DATE: August 25, 2015
TO: Honorable Mayor and Council Members
FROM: John C. Gilbert, Village Manager
RE: Fernwood and West Heather Intersection Improvements

Re: Review of Fernwood/W Heather Intersection Proposed Changes

W HEATHER DR. & FERNWOOD RD. INTERSECTION IMPROVEMENTS

RAISED INTERSECTION OPTION

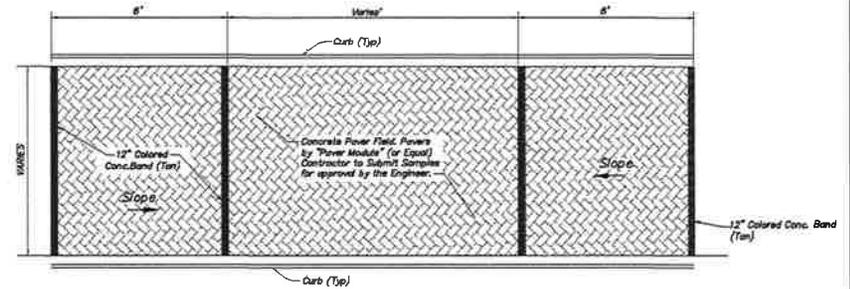
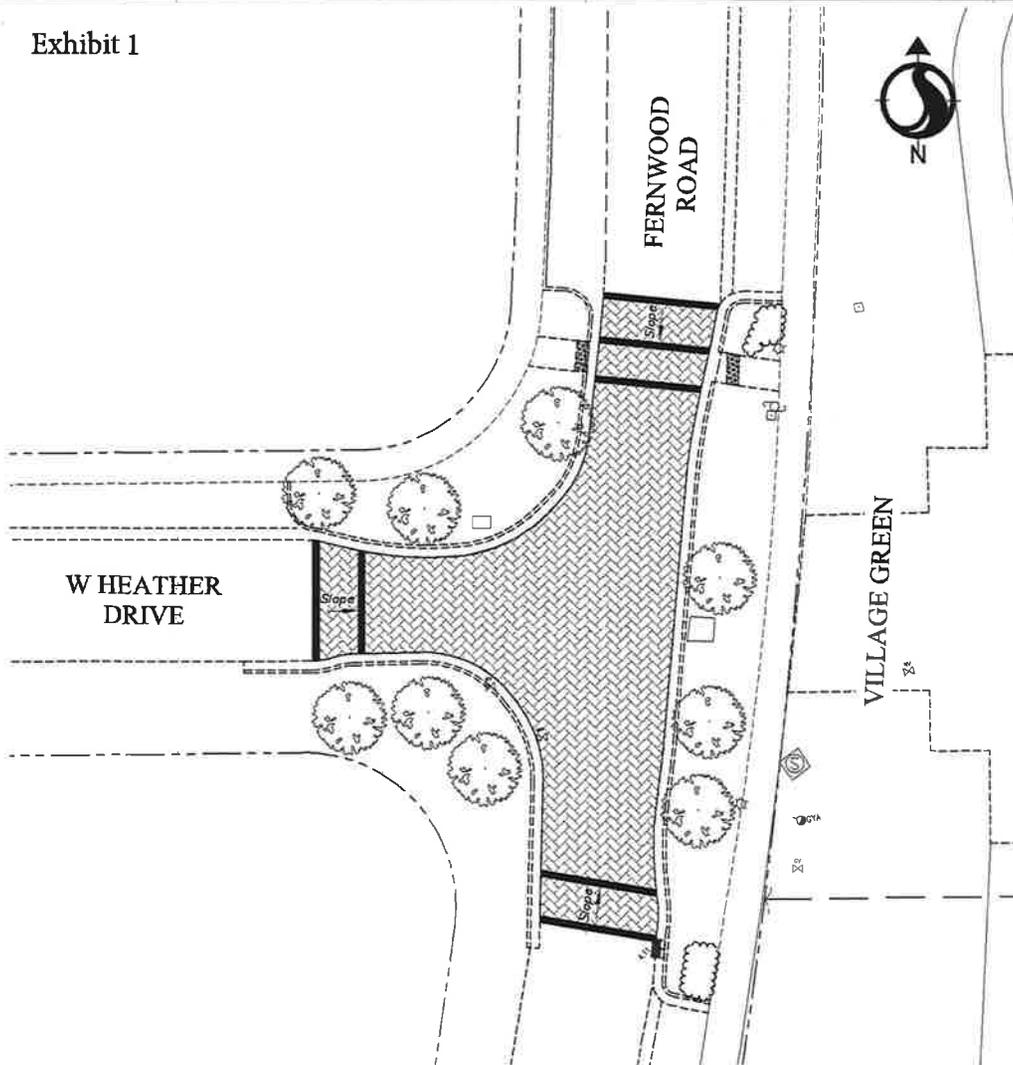
RAISED INTERSECTION OPTION (RECOMMENDED)

Raised Crosswalk	Raised Intersection	Traffic Circle
Raised crosswalks improves accessibility by allowing a pedestrian to cross at nearly a constant grade without the need for a curb ramp and makes the pedestrian more visible to approaching motorists.	Raised intersections reduces through movement speeds at intersection.	Roundabouts are safer than traditional stop sign or signal-controlled intersections.
Raised Crosswalks decreases motor vehicle speeds.	Raised intersections are more pedestrian-friendly.	Roundabouts work great as calming devices slowing traffic speed while improving traffic flow.

Raised Crosswalk	Raised Intersection	Traffic Circle
Raised crosswalk has to be at least 50' from any intersection. This is a fatal flaw with this design.	Raised intersections increases difficulty making a turn.	According to Miami-Dade County Standards for a 50' R/W road the minimum inside diameter is 35'. This is a fatal flaw with this design.
Raised crosswalk may be a problem for emergency vehicles and trailers.		The minimum traffic circle lane width required by Miami-Dade County is 16', although the county has recently began to allow 15' wide circulatory lanes. This is a fatal flaw with this design.
		Raised splitter Islands must be provided on all approaches.
		It is especially difficult to obtain the required deflection of all through movements at T-intersections. Even if a larger circle is explored we do not believe the appropriate deflection can be achieved.
		If a bigger traffic circle design is explored, please note that at each corner of the intersection a minimum of 2.5 feet of utility strip is not

- Raised Intersection (See analysis above).

ROUNDAABOUT OPTION

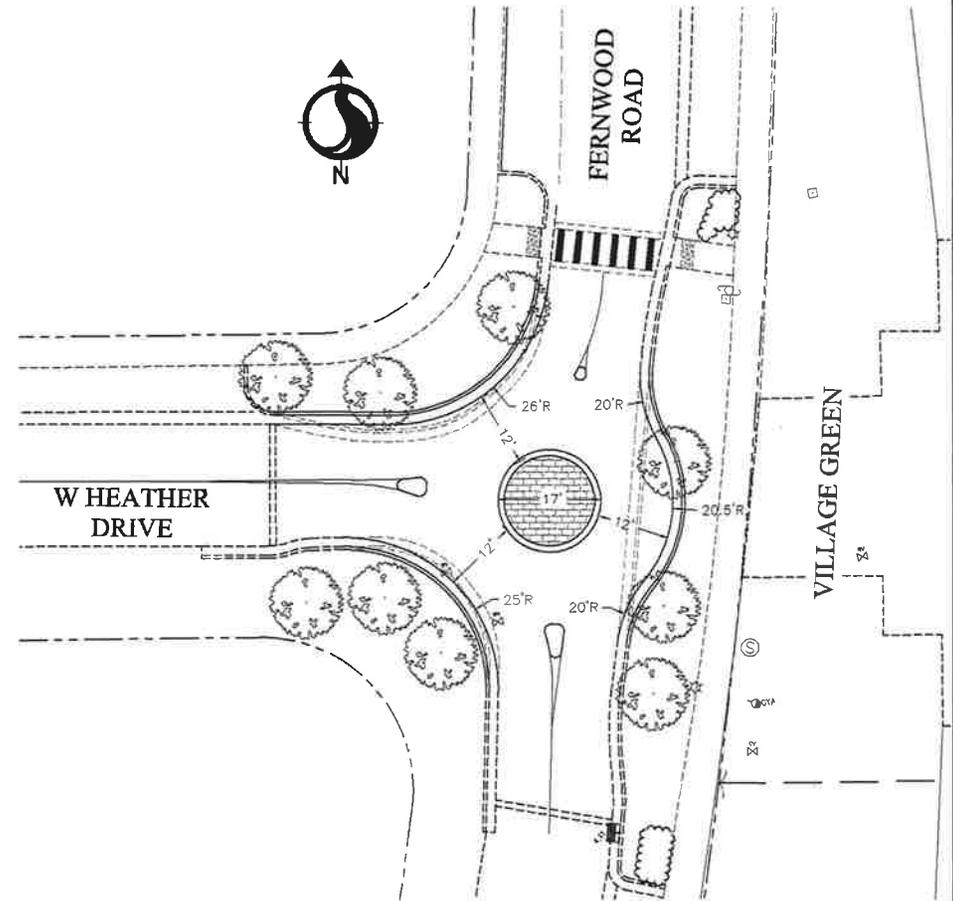
required between the face of sidewalk and the back of curb.
		A larger traffic circle will impact many of the trees adjacent to the intersection which will require further permitting efforts.
